# 400 SERIES TWO POWER AMPLIFIER

## *Service Manual*

*Phase Linear*

## 8-0. Service Bulletins and Supplements

## Model 400II/700II (Complimentary)

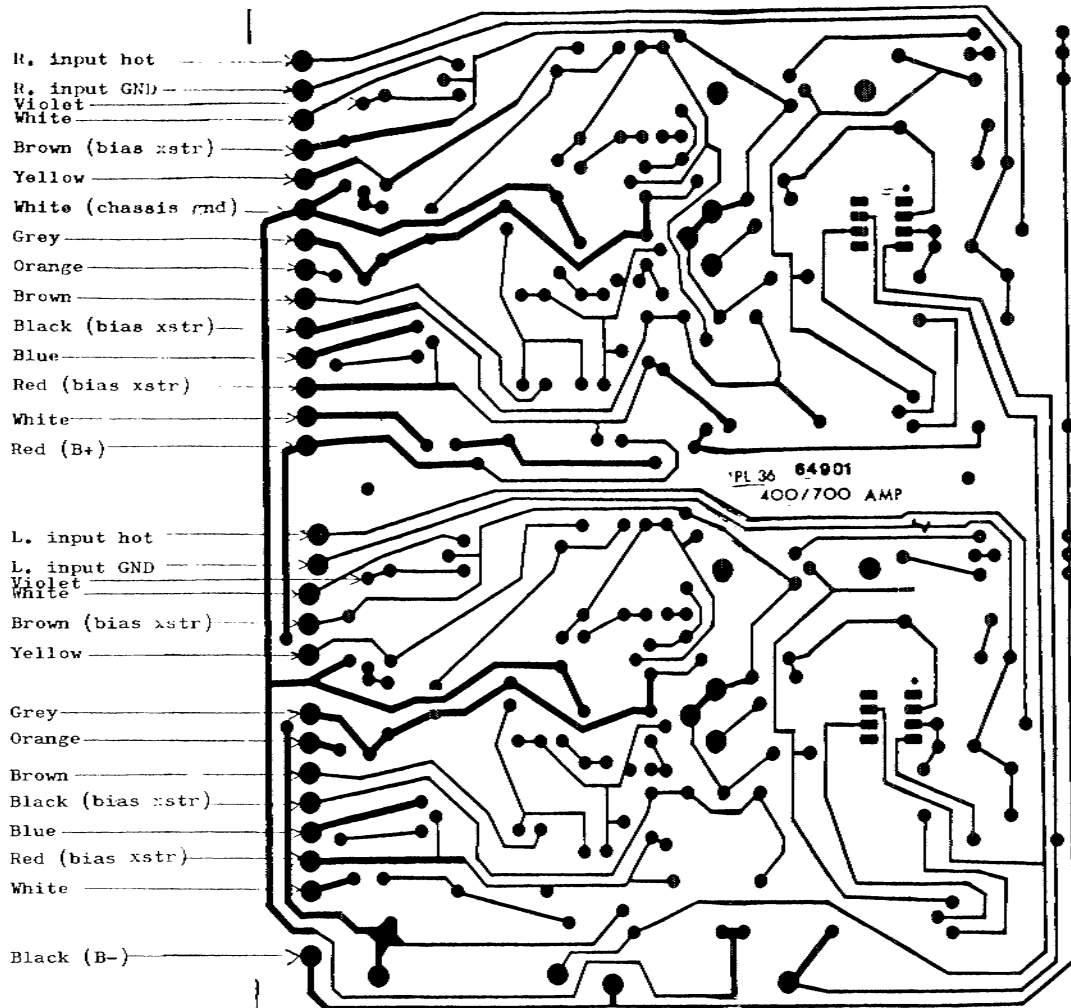
Subject: Revision of model 700II and 400II from quasi-complimentary to full complimentary output stages.

700IIs beginning with serial number 7A10701 and 400IIs beginning with serial number 4A31658 contain fully complimentary output stages. XPL909s (Delco) and FPL909s (Fairchild) are no longer used. The new amps will have either TP9054 NPN (Motorola MJ15024) and DB15025 PNP (Motorola MJ15025) or 2SD555 NPN and 2SB600 PNP (NEC brand) output transistors. An added advantage to this change is that we now use the same devices for both output and output driver transistors.

The drive PCBs are identical except for the value of R127&128 (56k for the 700II and 82k for the 400II). Refer to the revised wiring diagram below and the enclosed revised schematic.

Phase Linear  
 PCB SCHEMATIC  
 AMPLIFIER  
 7000 SERIES TWO (COMP)  
 SIZE 400  
 DWG. NO. 210-0290-0  
 REV. A

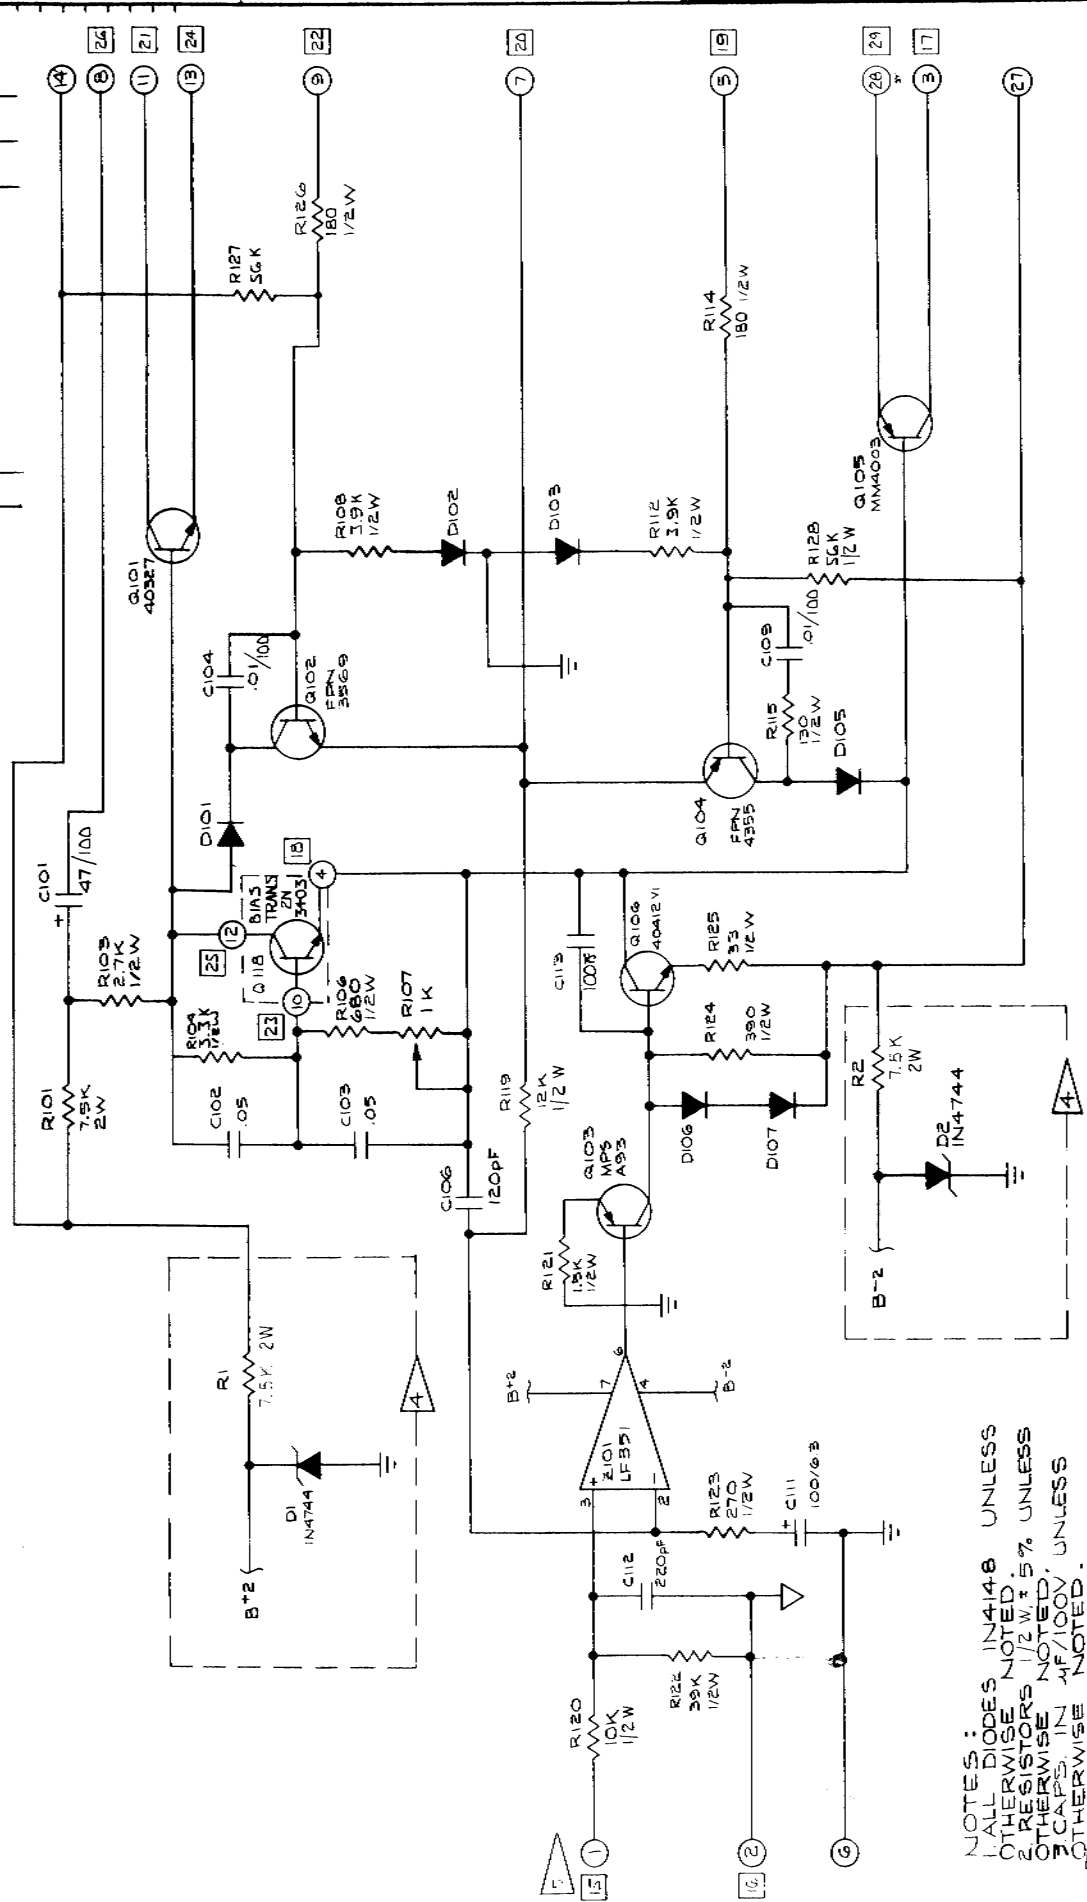
REV	DESCRIPTION	BY	DATE	APPROVED
B	CHG ID XFORMER TO DUAL PRIMARY - ZONE A-4	TUN	2-6-76	JP
C	ZONE C-2 WAS R135, R136 10KΩ 243. 5-10			
D	IS R135 5A-5W			
E	CORRECTION PER AUDIT PER EGO 734 NOTE 4 WAS XPL 909 502K 1-2979 OR FR 909			
F	PER EGO 820 ZONE C11 C2, R134 502K 1-1779			
G	R137 WERE 82K NOW 120K PER EGO 1035 - ADDED CAP 5-ZONE A-3

Phase Linear
SCHEMATIC DIAGRAM
700 SERIES TWO (COMP)
INTERCONNECT

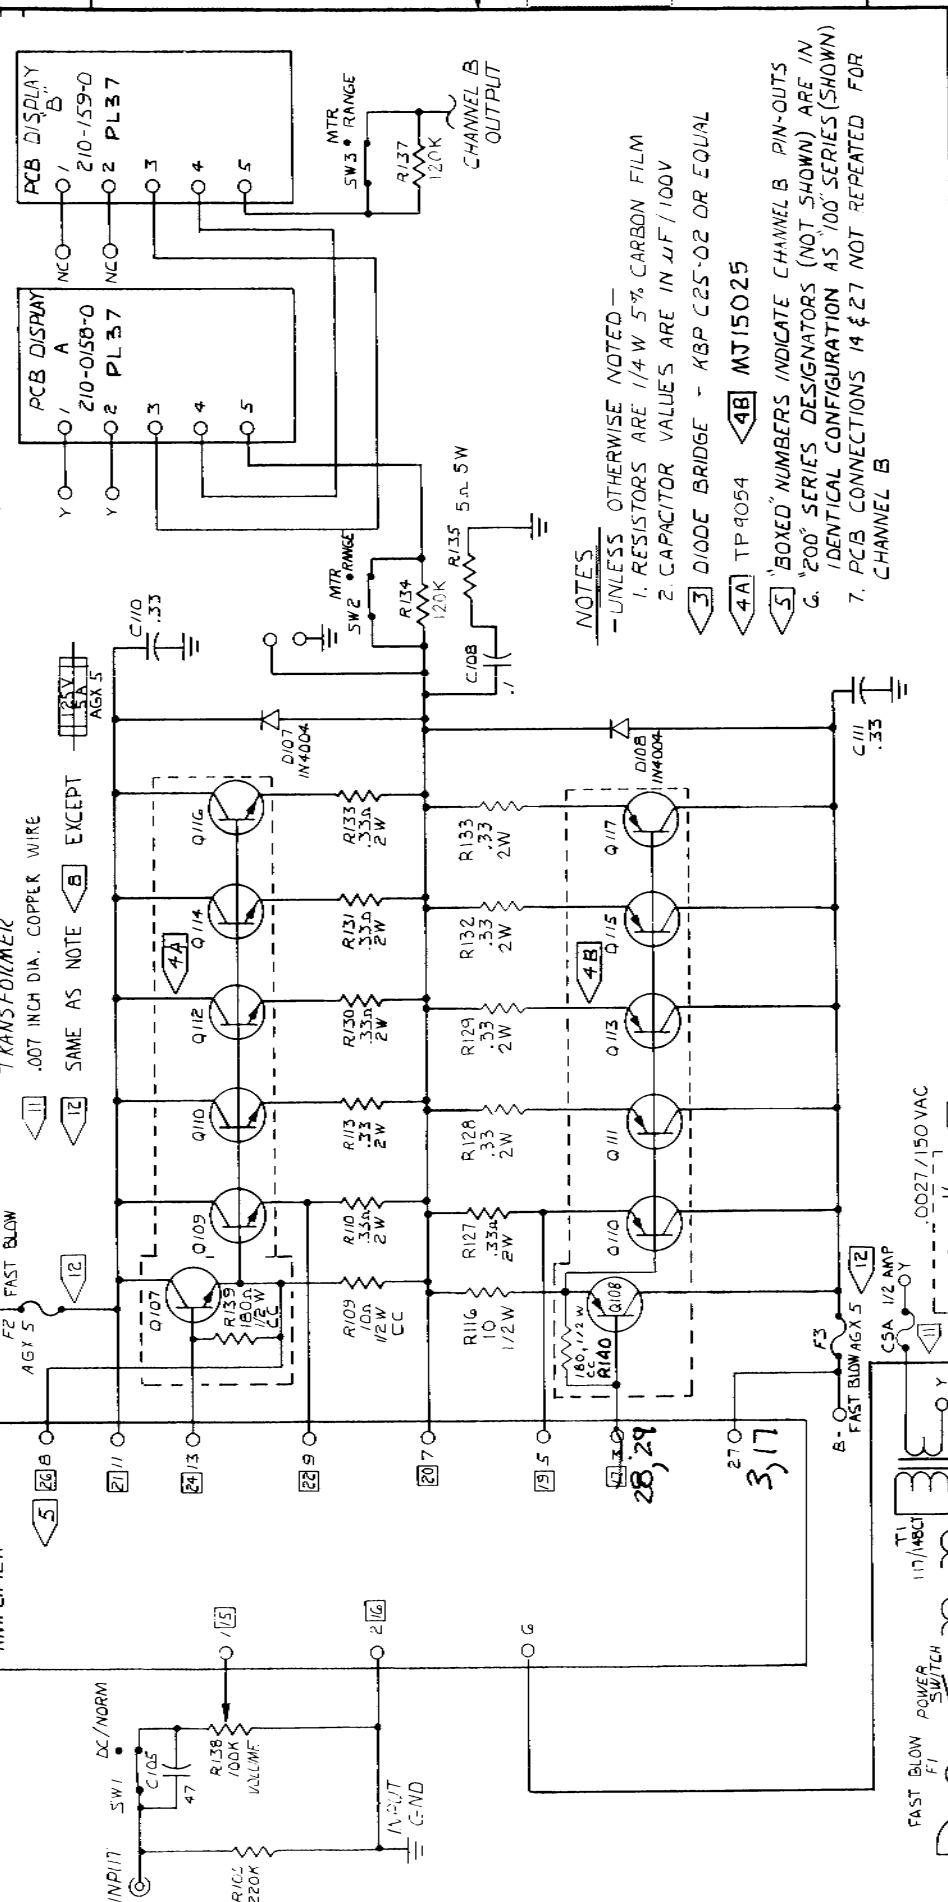
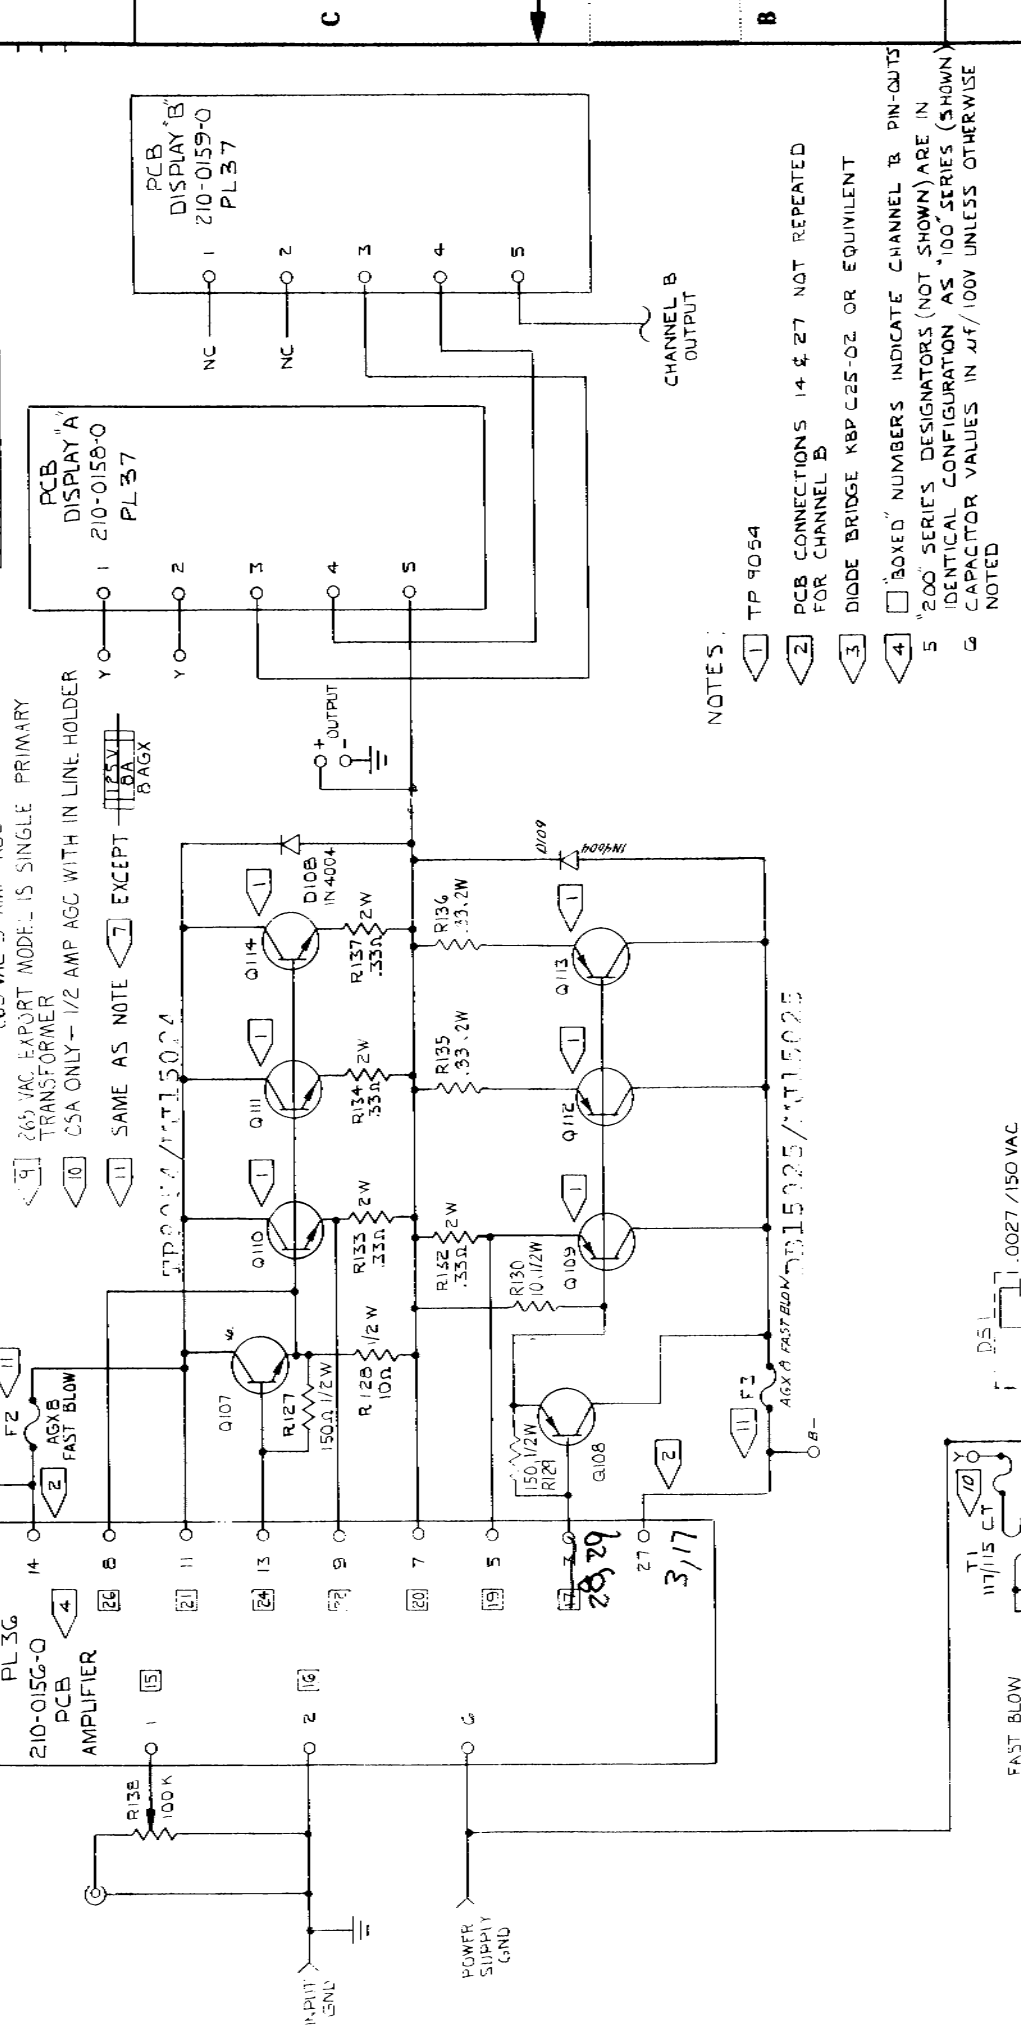
REVISIONS		
LTR.	DESCRIPTION	BY DATE APPROVED
B	CHG. D. XFORMER TO DUAL PRIMARY - ZONE A-4	TJN 2/6/78
C	CORRECTION PER AUDIT	JC/AC 8/3/78
D	PER ECR 7/23	6/8/78 7/1/78
E	PER ECO 1034- ADDED CAPS ZONE A-3	6/8/78 7/1/78
F	PER ECO 1229	10/4/78 10/22/78
G	PER ECO 1313 - NEW RELAY BD.	10/4/78 12/31/78
